**ADDENDUM NO. 1
FEBRUARY 26TH, 2026**

PROJECT: ANSON ISD
ELEMENTARY & HIGH SCHOOL CLASSROOM ADDITION

BID DATE: MARCH 5TH, 2026

1A5.0

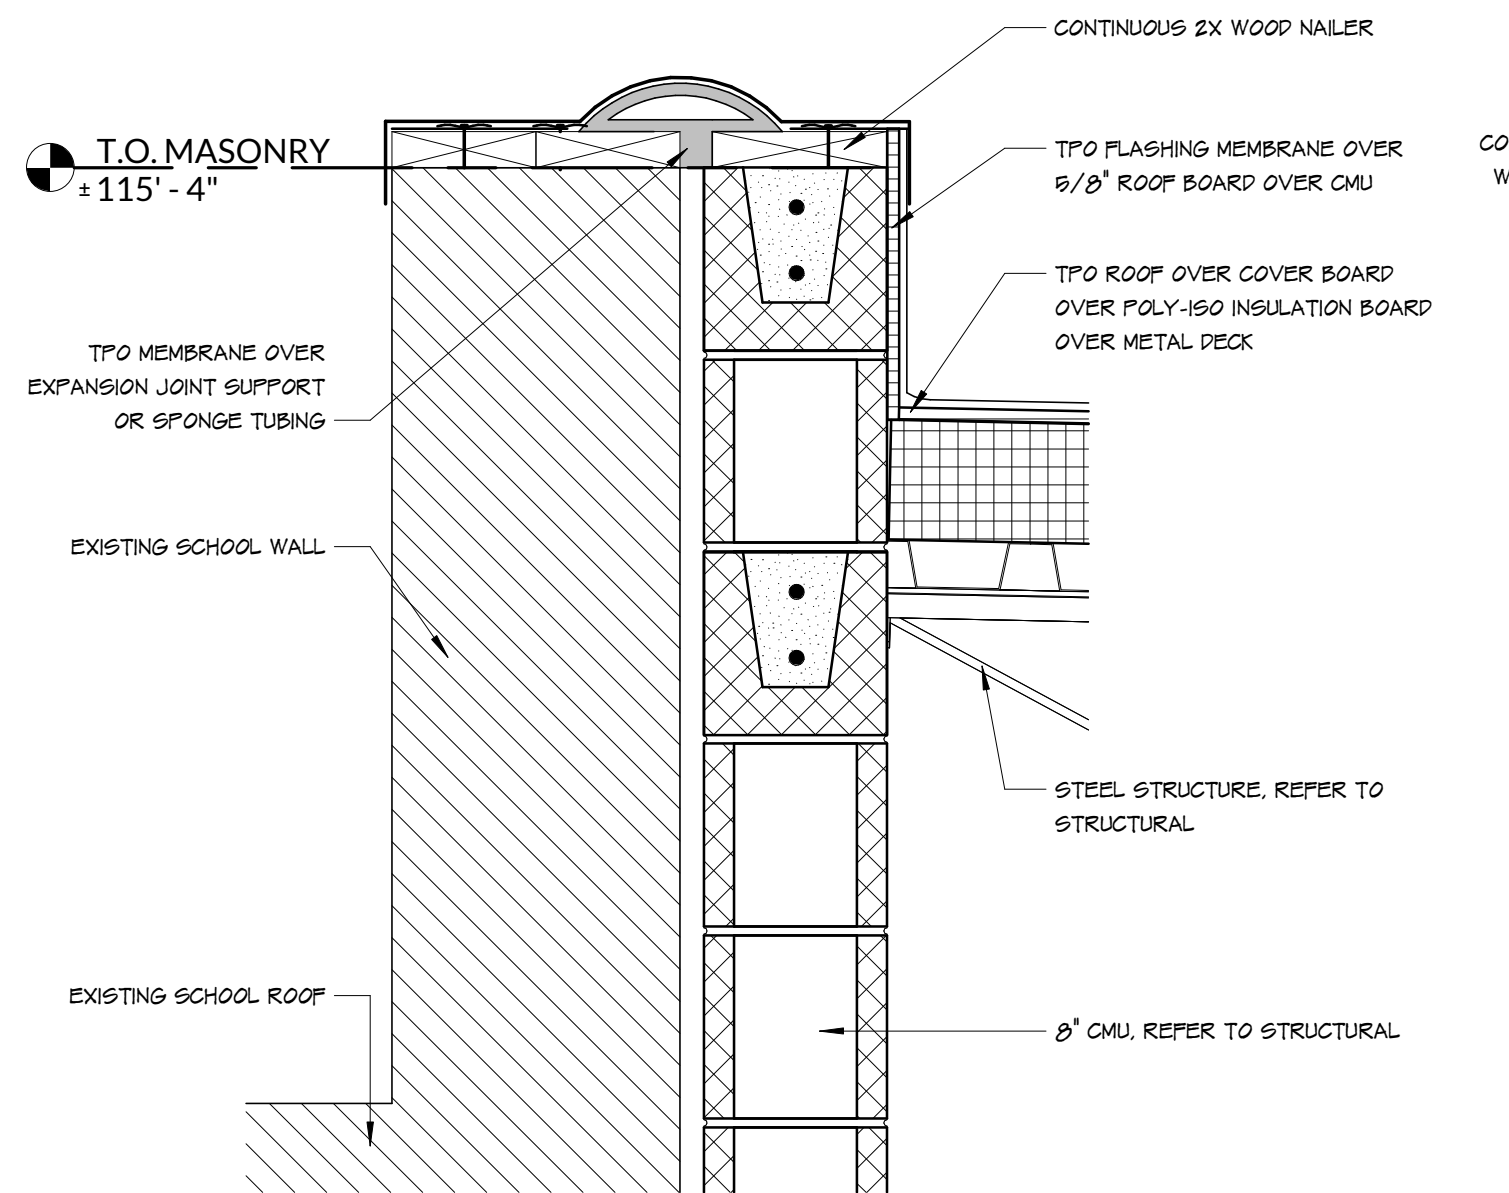
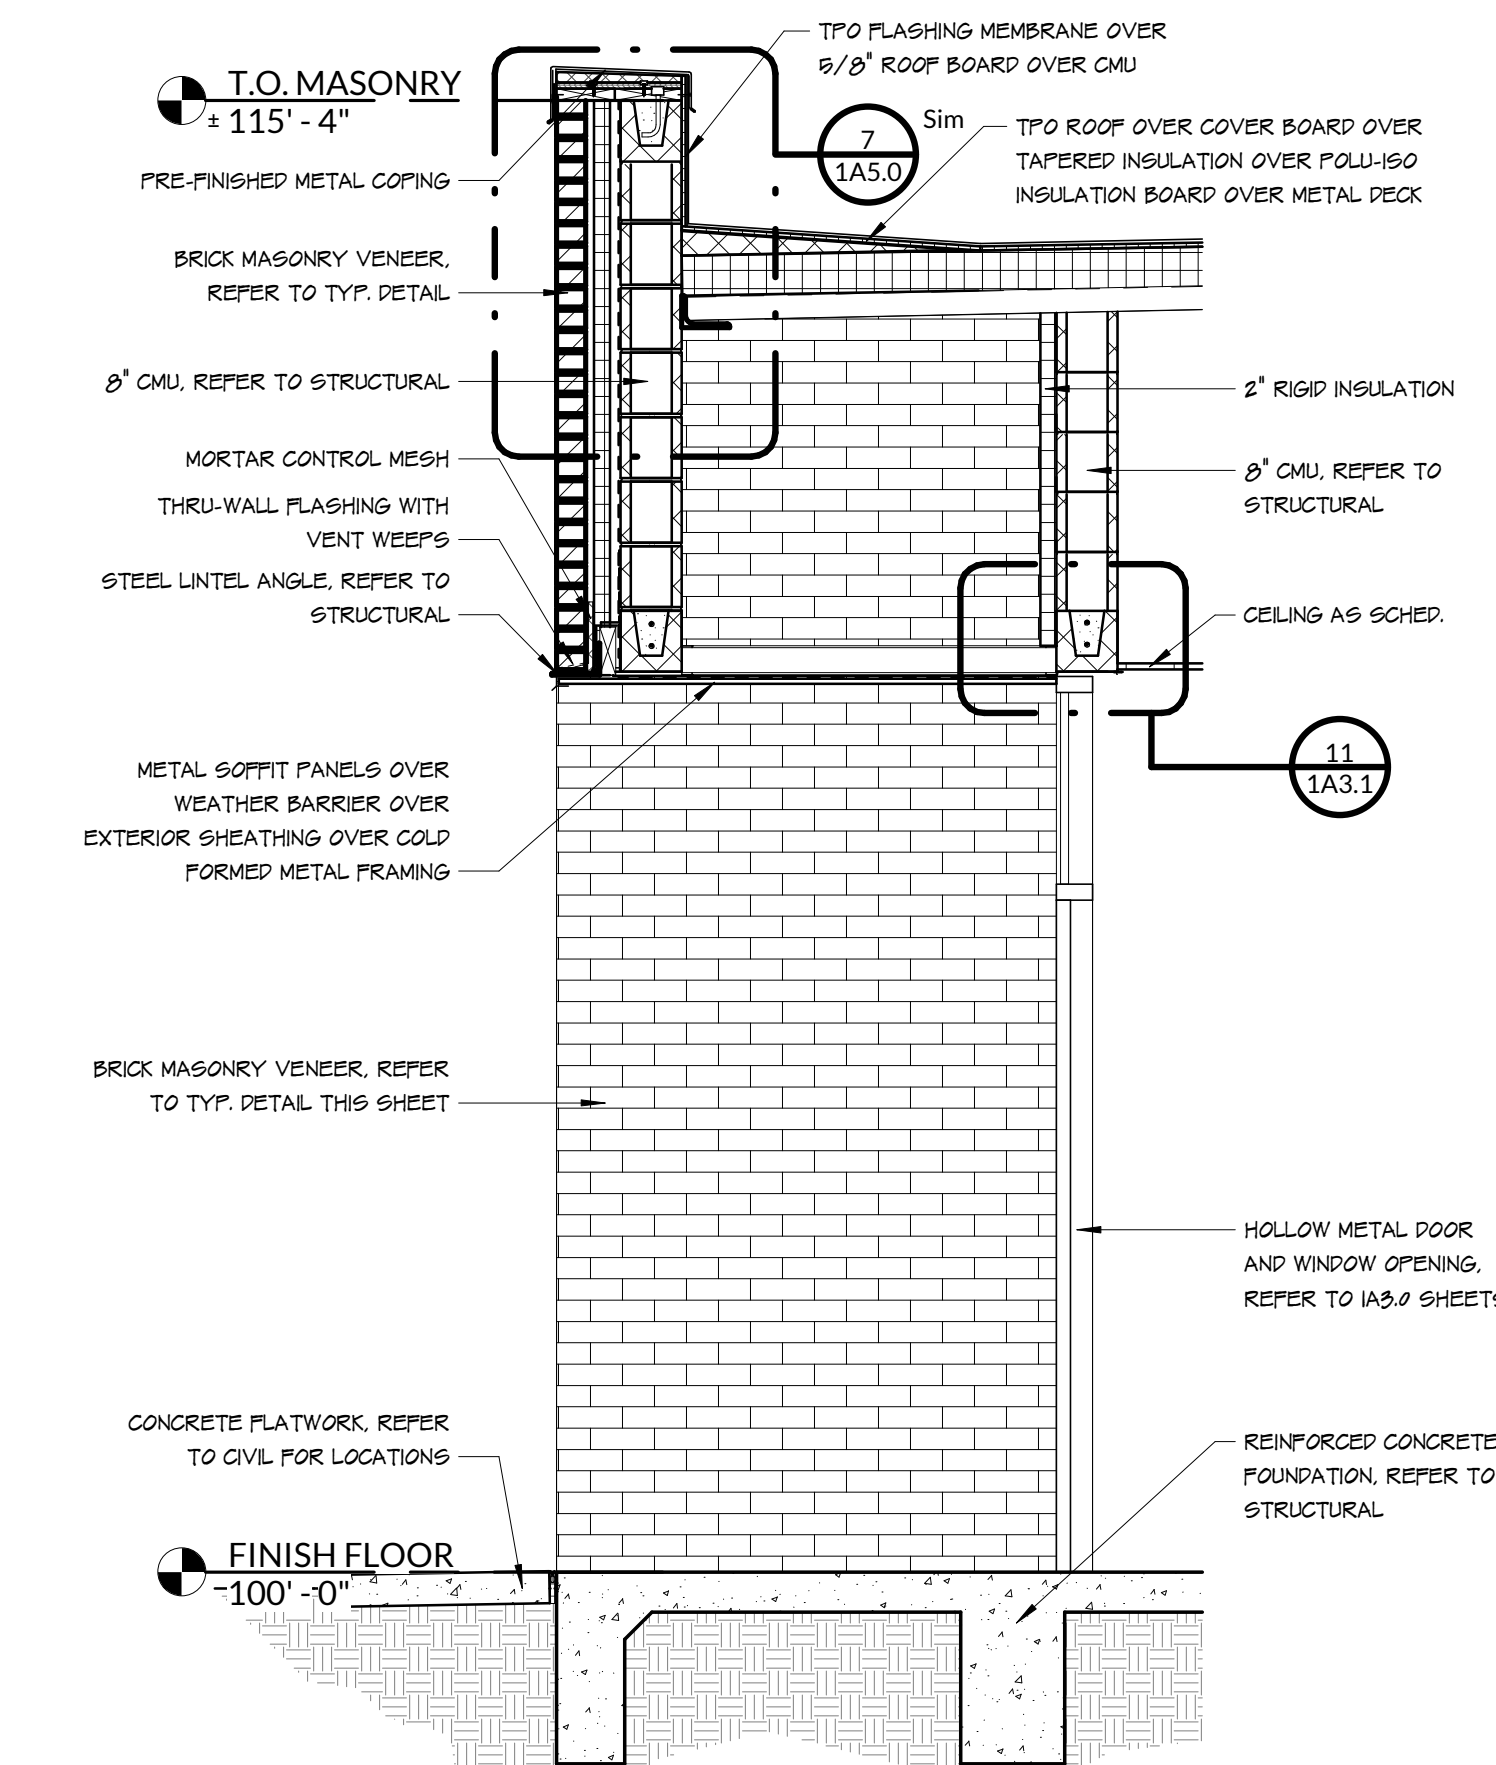
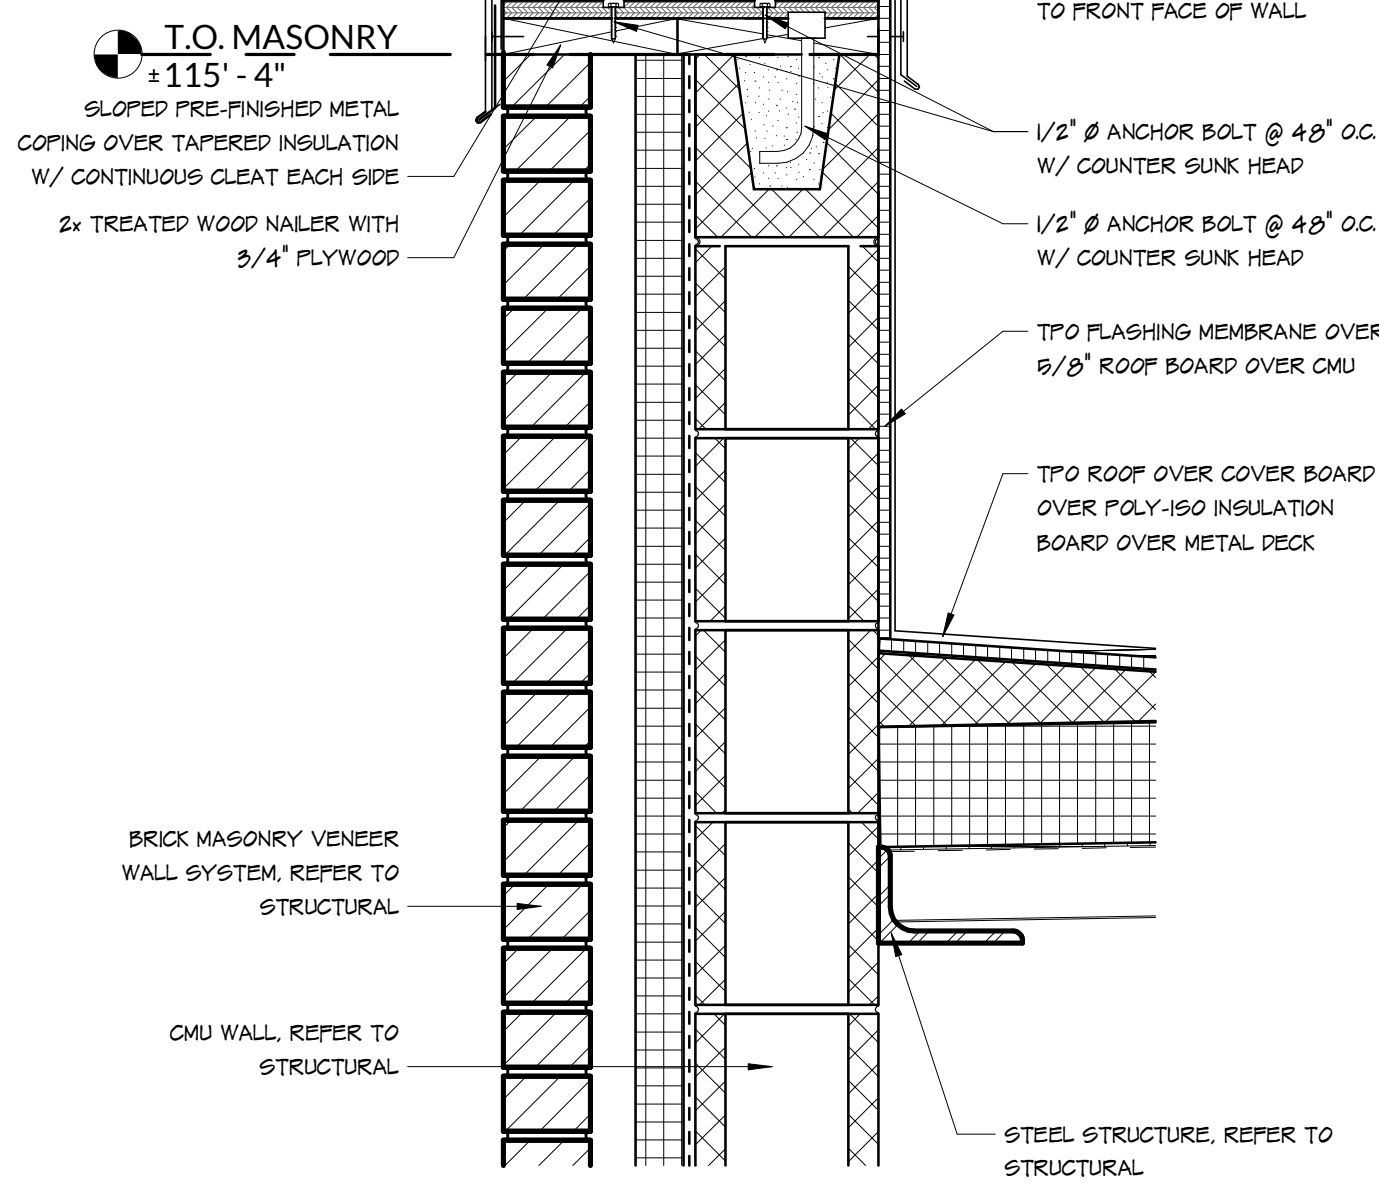
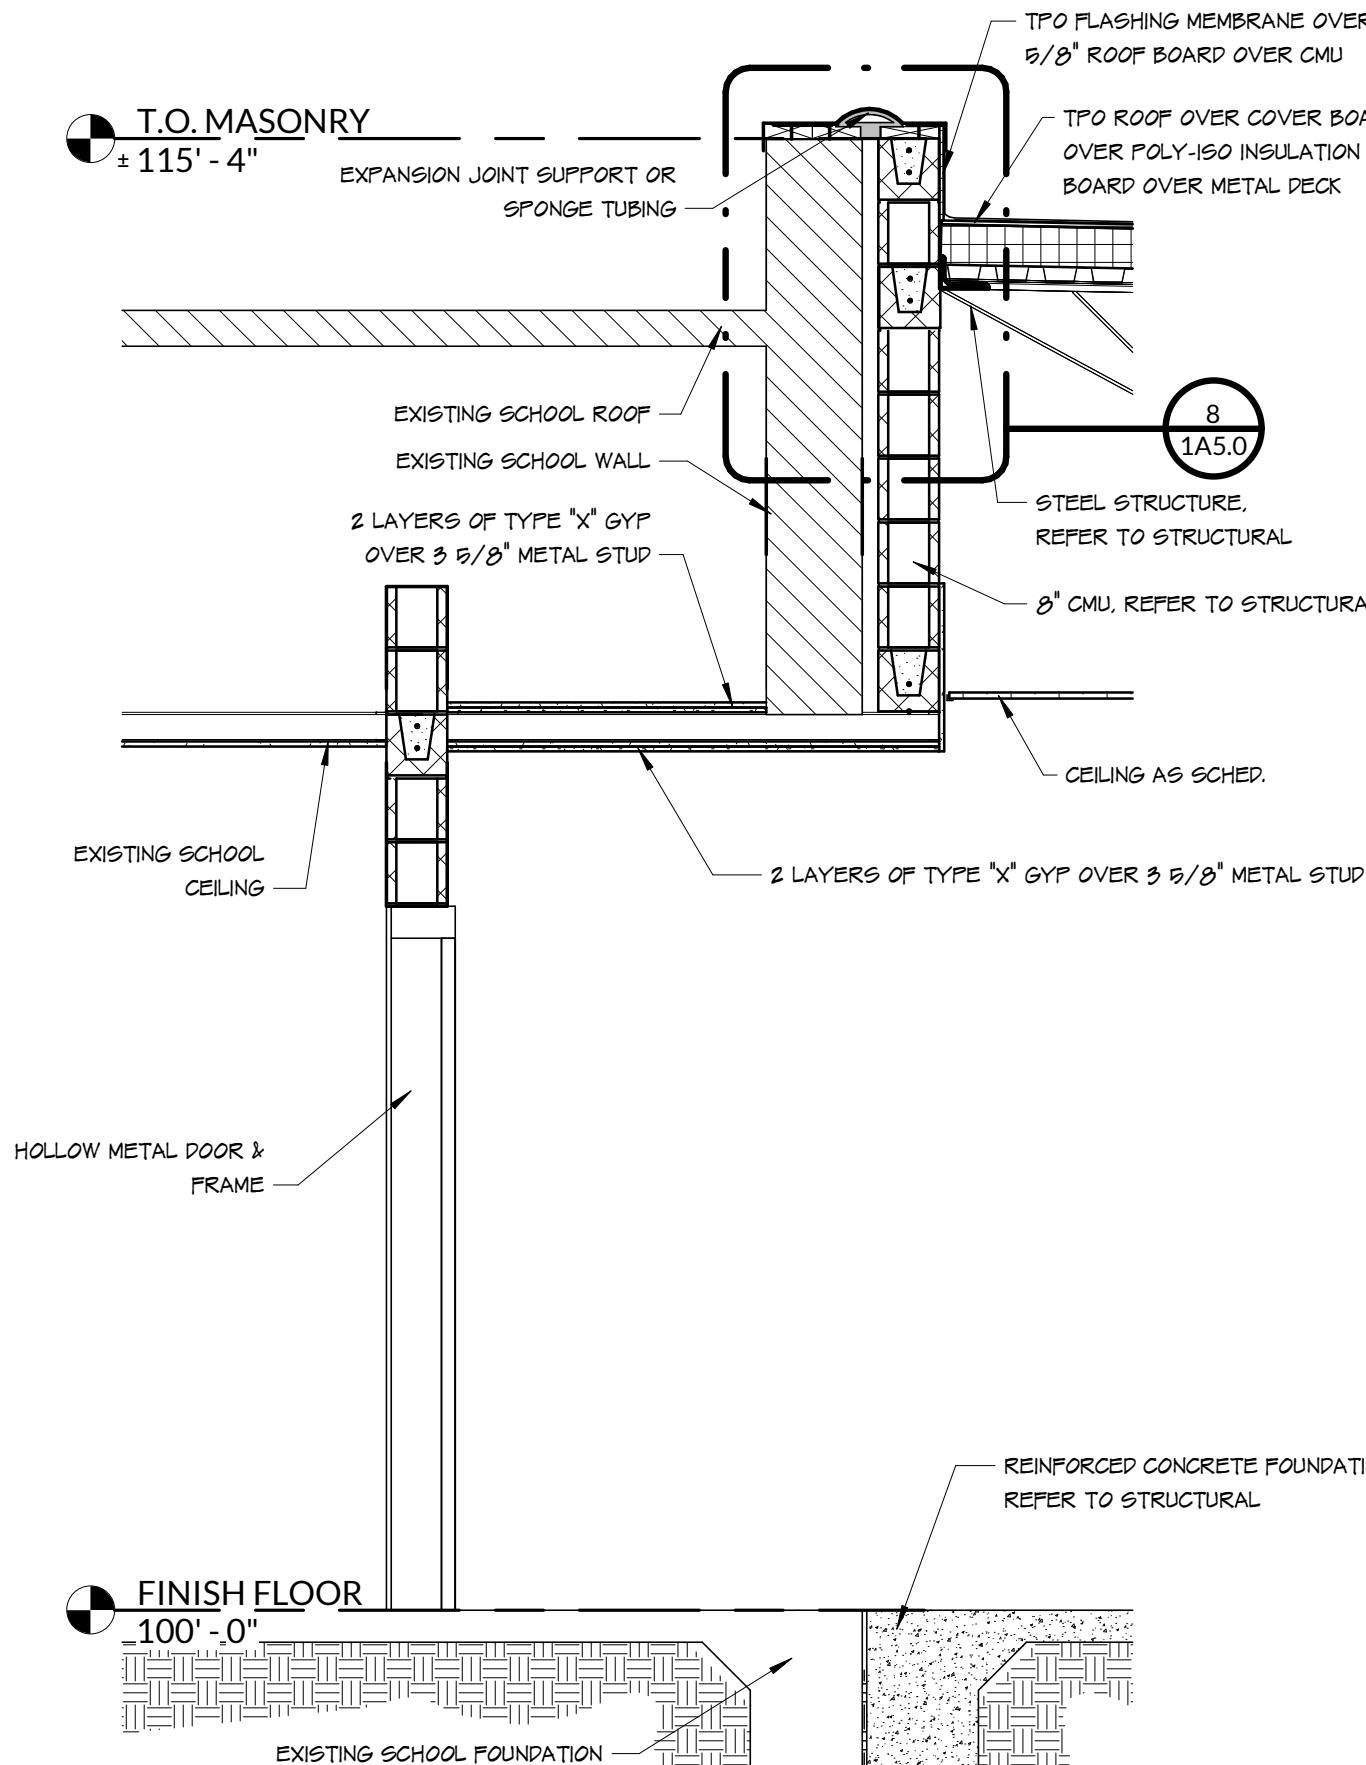
- Item #D1** **Sheet 1A2.1** – REPLACE sheet with attached sheet 1A2.1 dated 02-26-2026. UPDATED room finish schedule ceiling heights.
- Item #D2** **Sheet 1A5.0** – REPLACE sheet with attached sheet 1A5.0 dated 02-26-2026. UPDATED wall sections showing raised top of steel & lowered ceiling heights.
- Item #D3** **Sheet 1A7.0** – REPLACE sheet with attached sheet 1A7.0 dated 02-26-2026. UPDATED reflected ceiling plan with updated lighting layout in Vest. 100 & ceiling heights.
- Item #D4** **Sheet 1S1.0** – REPLACE sheet with attached sheet 1S1.0 dated 02-26-2026. UPDATED plan with missing non-load bearing CMU walls & added dimensions.
